DATE: AUGUST 24, 2026

ADDENDUM NO.: 2

PROJECT: A NEW BRANCH OFFICE
1208 Texas Research Parkway (SH211)
[211 and Potranco]
(Bexar County)
San Antonio, Texas 78245

SSI – 1 (Addendum-2)

E2.1

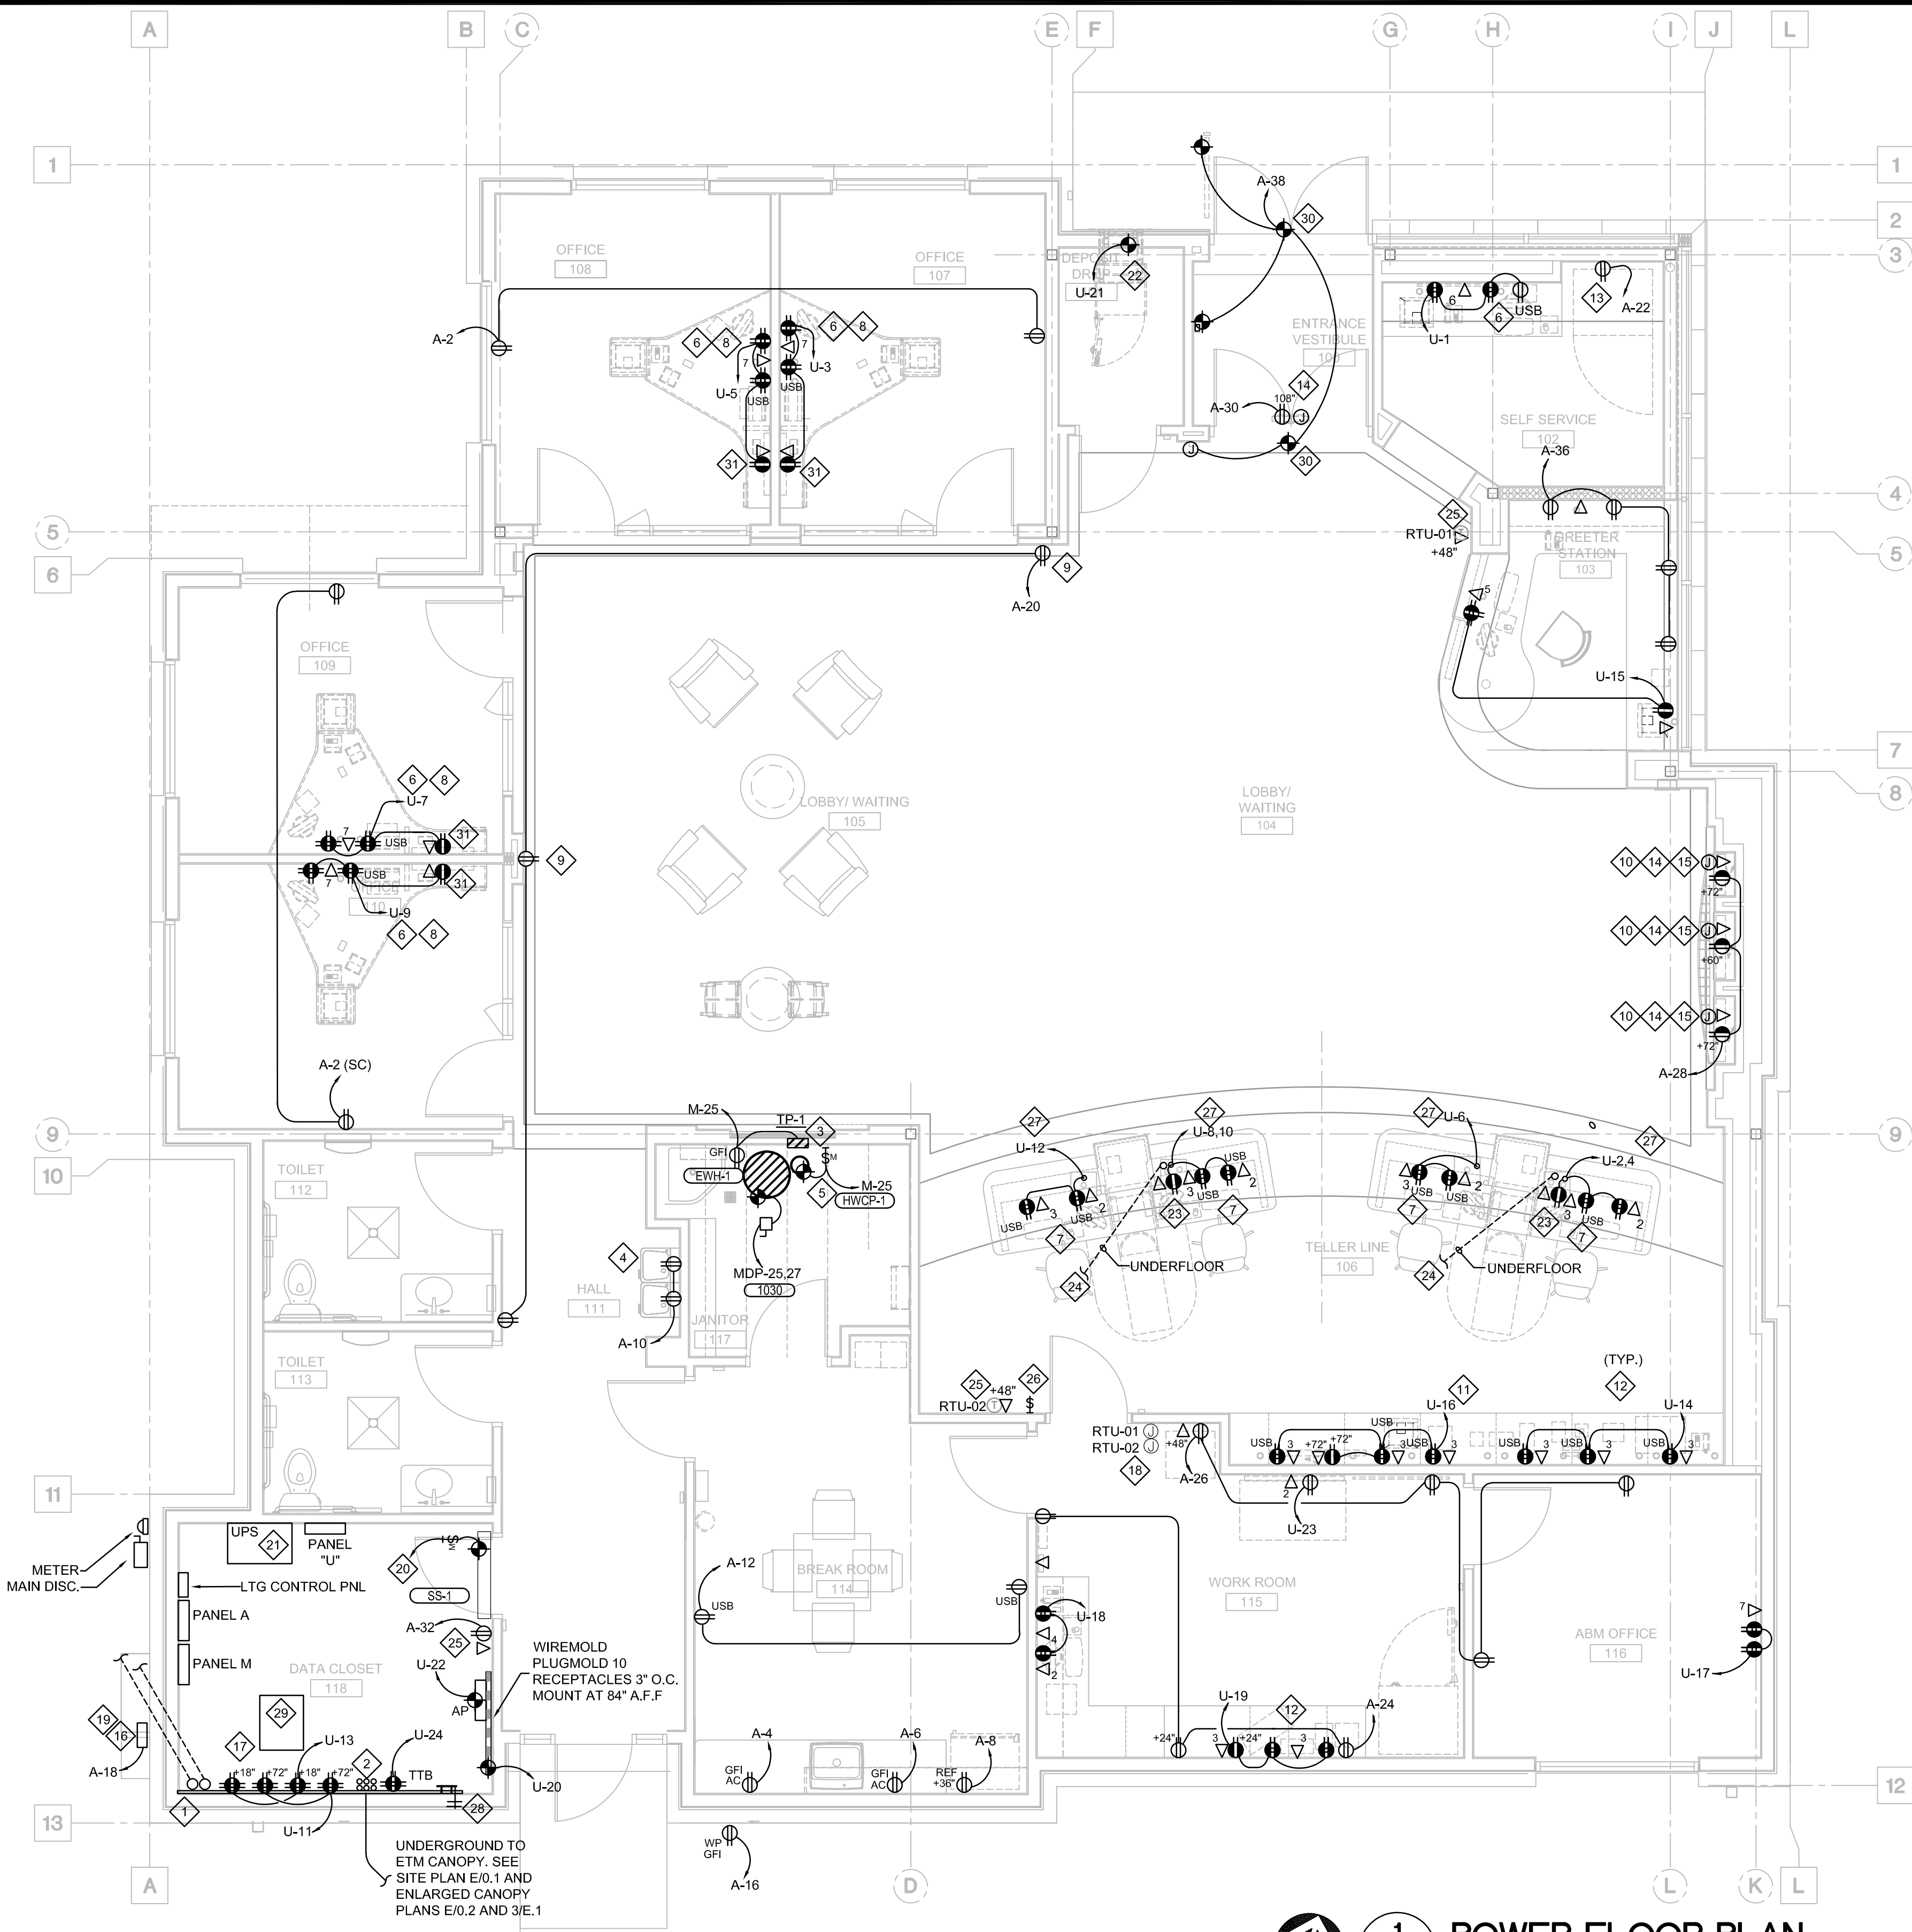
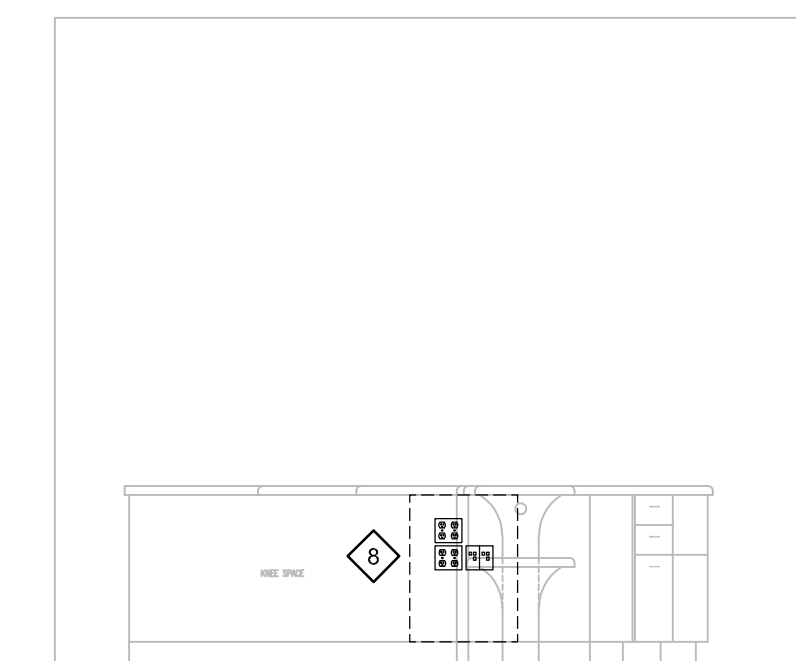
1. Sheet E2.1 - Power Floor Plan
 - a. See updated office detail. See attached sheet.

Roof Framing Plan

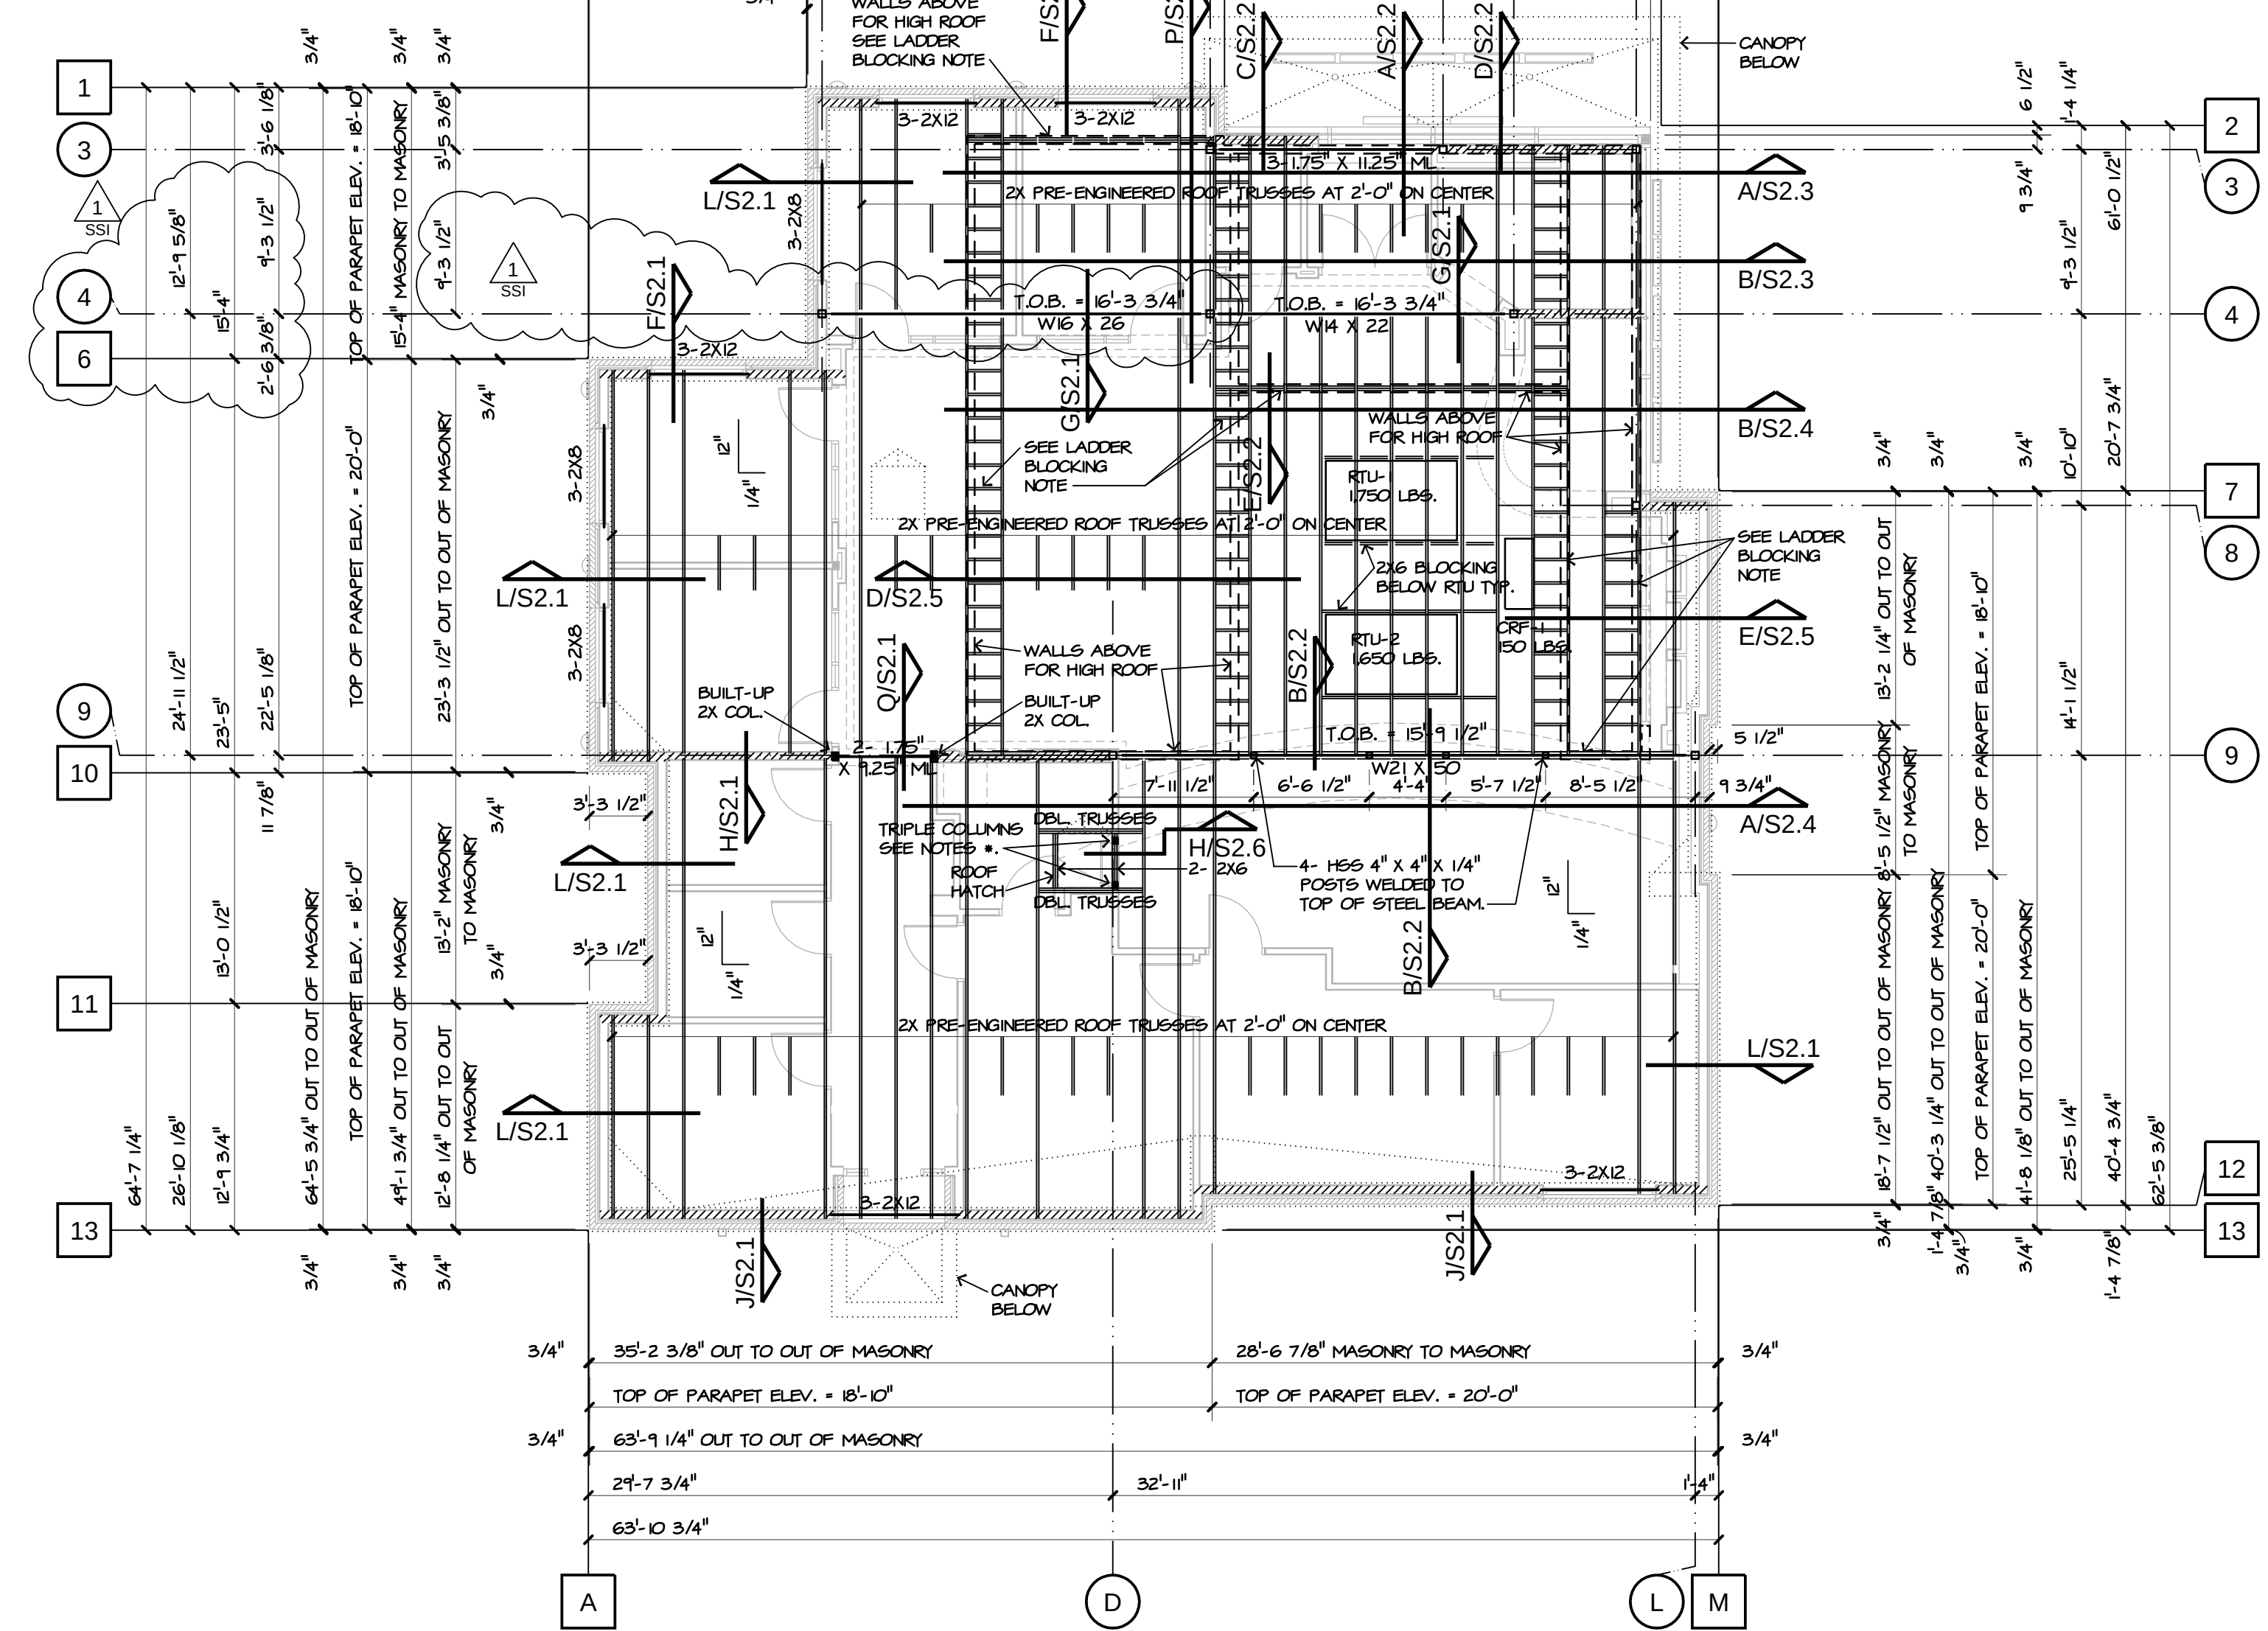
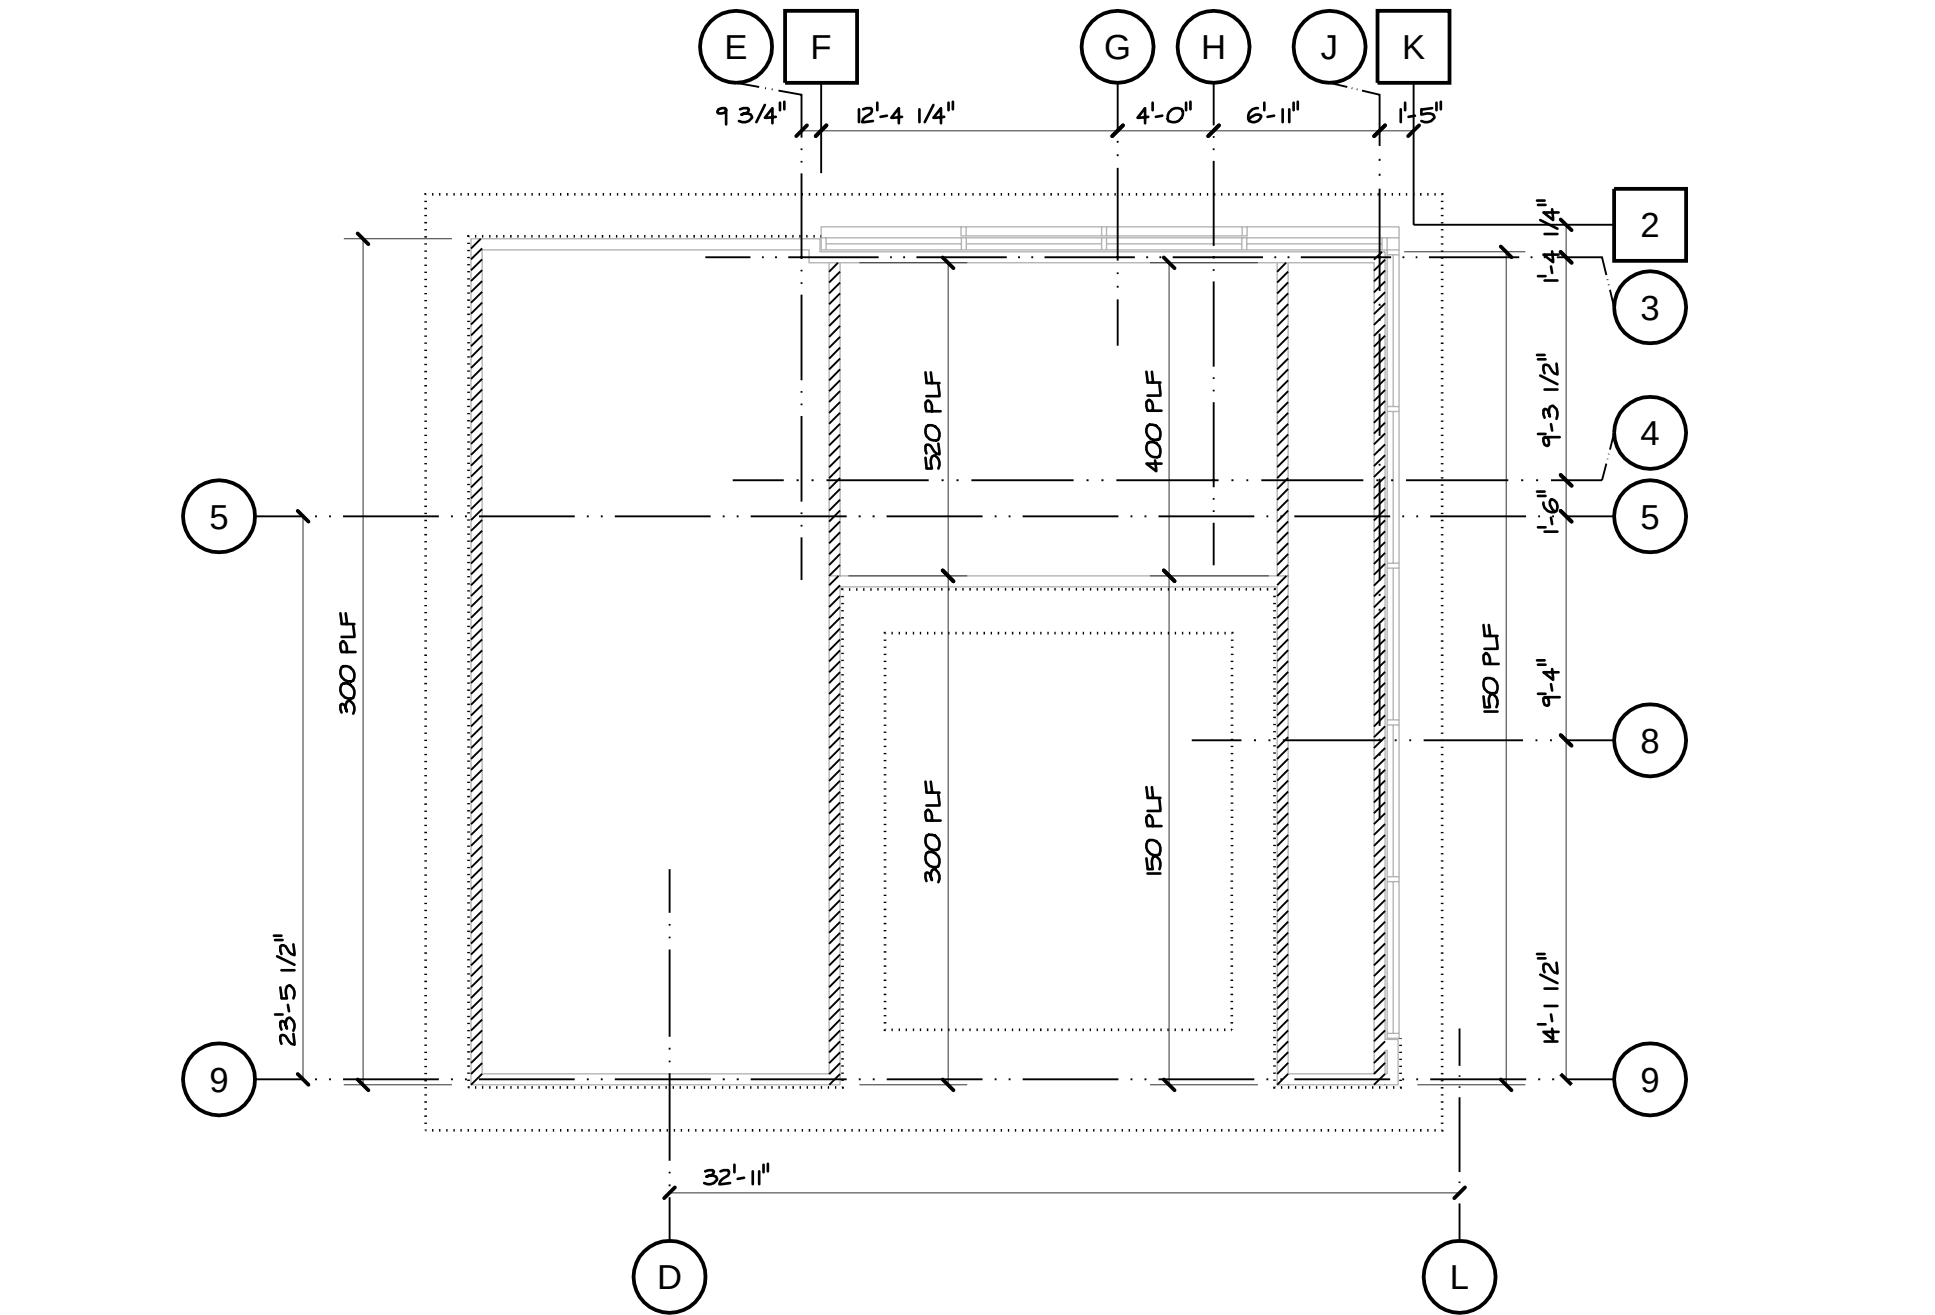
- ITEM 3) Sheet S1.3 – Roof Framing Plans – Changed columns C5 and E5 to C4 and E4 along with the W16x26 beam and omitted grid 5. Moved column C4 into stud wall space and omitted the HSS 4x4 post to roof at grid E4. Refer to Sheet S1.3, SSI-1 dated August 24, 2026.
